SERVICE BULLETIN

NUMBER: 12-203-16
DATE: 07/14/16

SUBJECT: Squeaking Sound from Front Seat Buckle

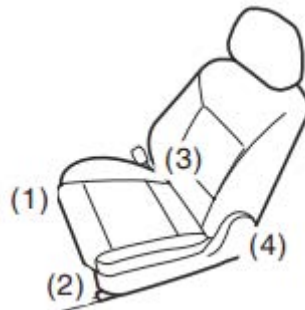
The 3 “tang” seen on the inside of the **OLD** wave washer have been deleted. The inside diameter of the **NEW** wave washer has been decreased and a small felt added to allow the washer to turn smoother with the buckle and have a better fit on the shoulder portion of the retaining bolt.

The part number for the new wave washer is **64168SG000**.
